# ORIGINATION FORM

Proposed Revisions to a Standard Plans Index  
(Please provide all information – Incomplete forms will be returned)

Index Number: 521-010  
Sheet Number (s): New Sheets 1,2  
Index Title: Opaque Visual Barrier

ELEVATION OF REINFORCEMENT AND DOWELING

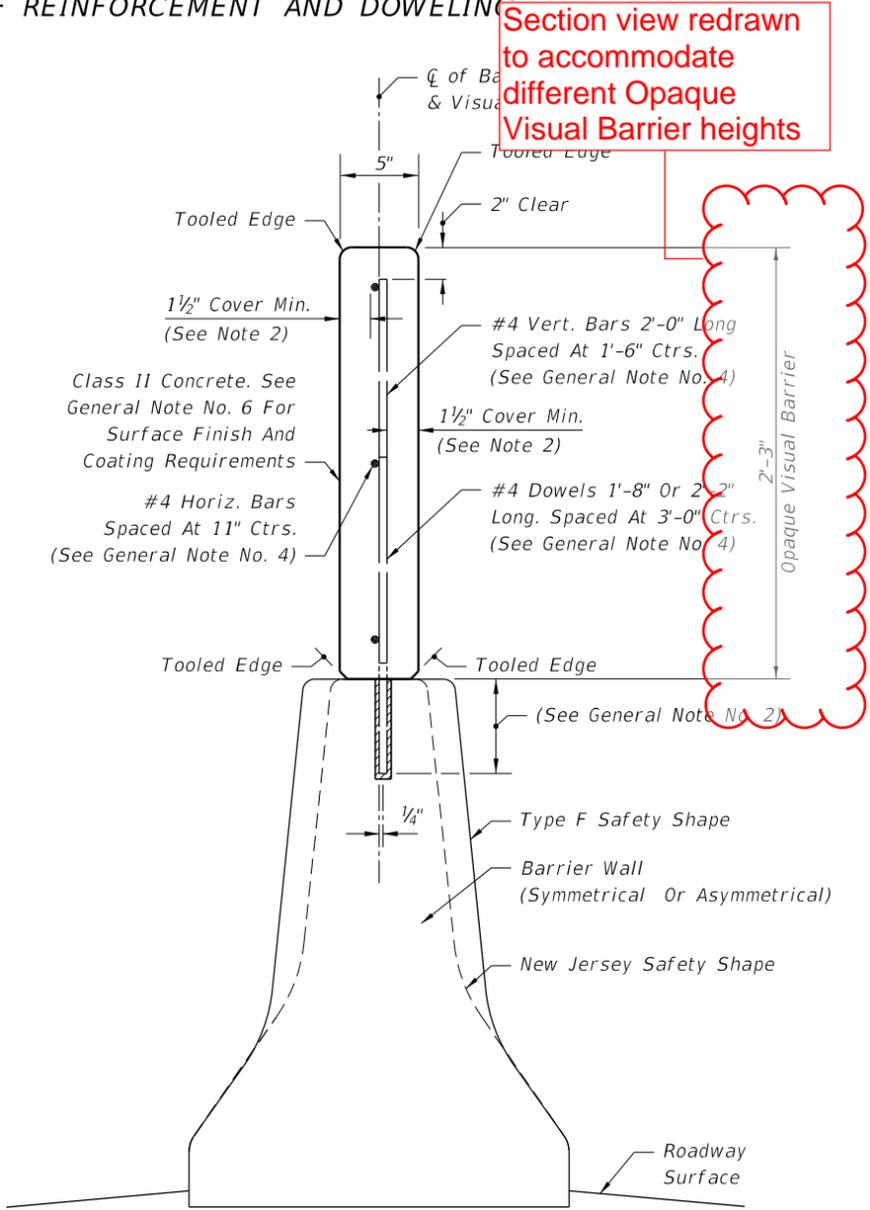
**Redeveloped Standard to update design and add additional features, including:**

1. new heights for Single-Slope Concrete Barrier, Traffic Railing, and all existing F-Shape
2. tighter spacing of reinforcing steel
3. minimum transverse joint spacing
4. "leave-out" concept for handling barrier-mounted structures
5. accommodation for welded wire reinforcing and variable barrier heights

END VIEW

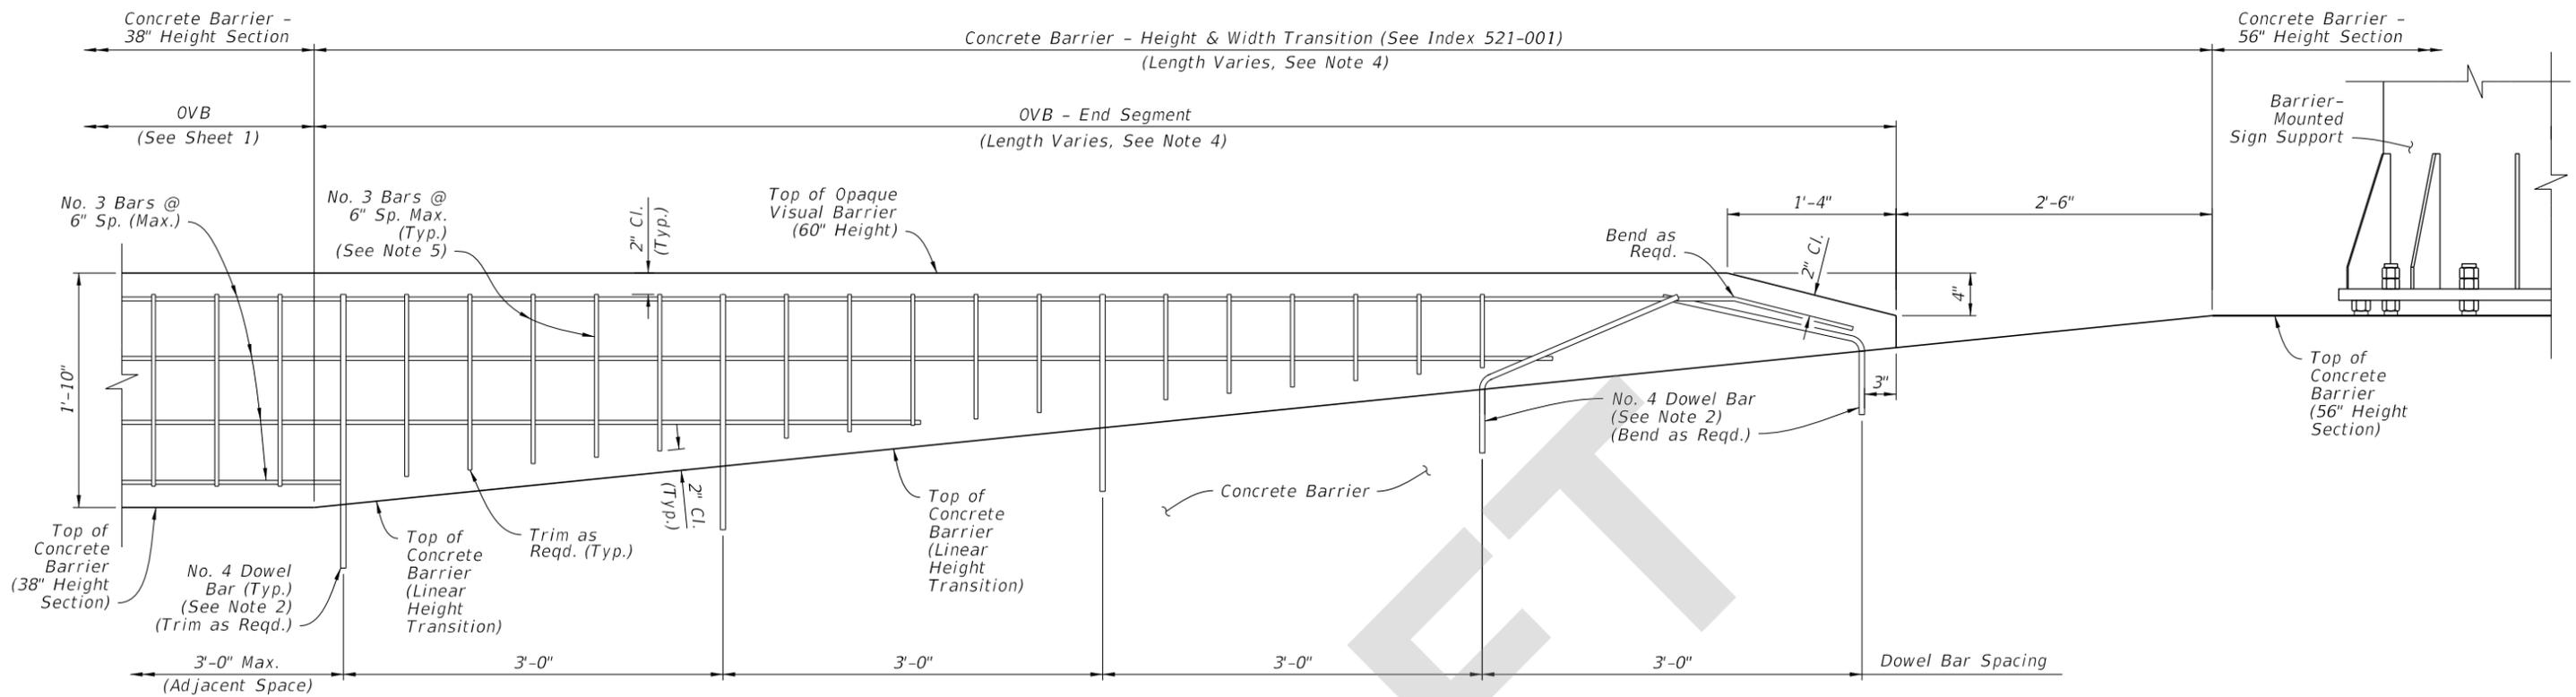
Notes re-organized for added features and clarity

**ELEVATION VIEW 'A' - OVB END SEGMENT AT CONCRETE BARRIER HEIGHT TRANSITION FROM 38" HEIGHT TO 56" HEIGHT SECTION (REVERSE DIRECTION SIMILAR BY OPPOSITE HAND)**

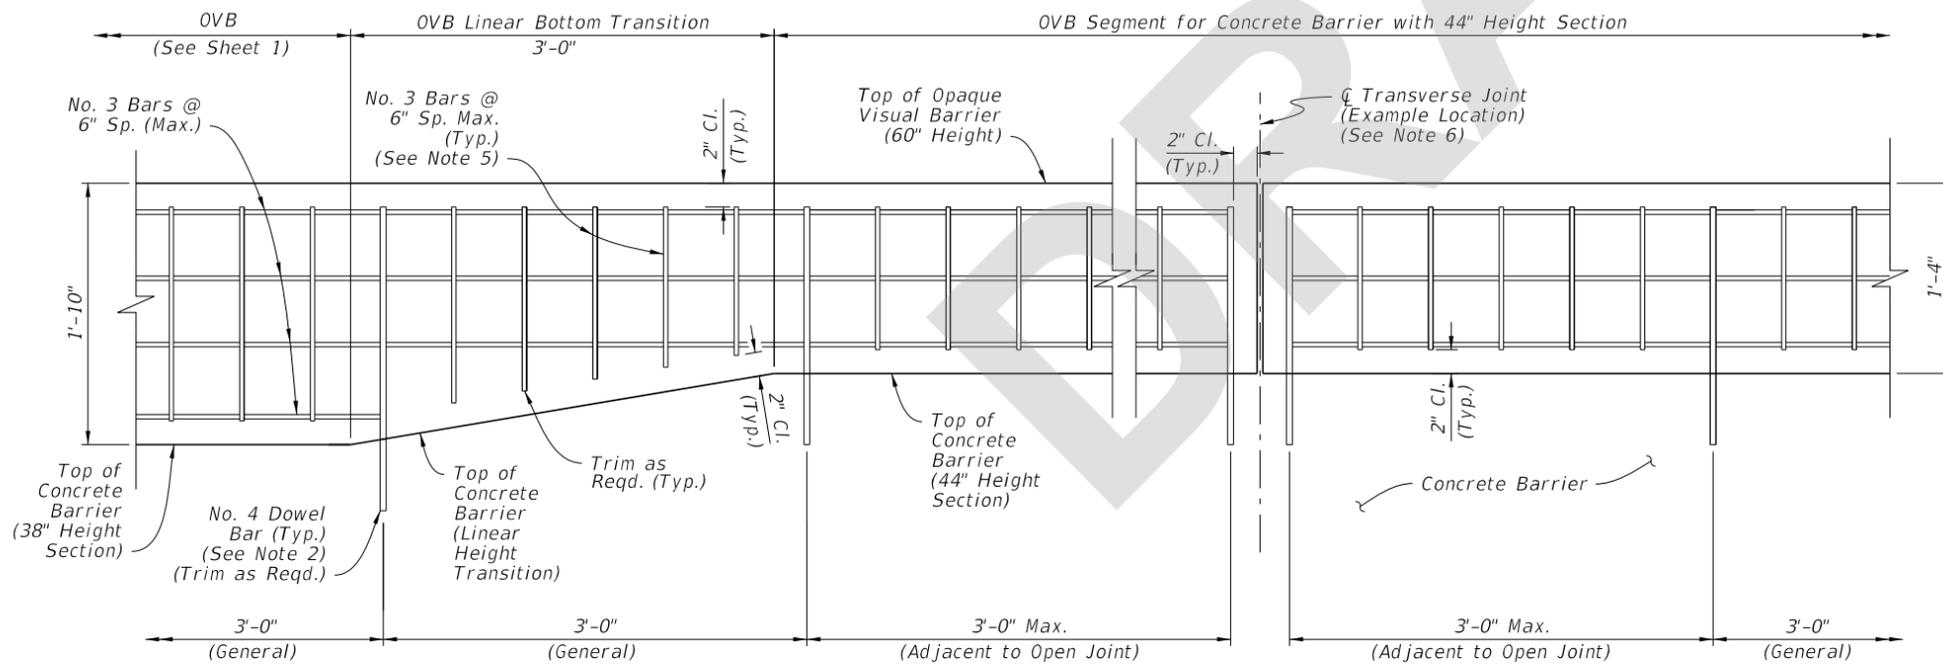
New Sheet 2: Add detail for discontinuation at 56" height barrier sections; Add detail for continuing over 44" height barrier sections
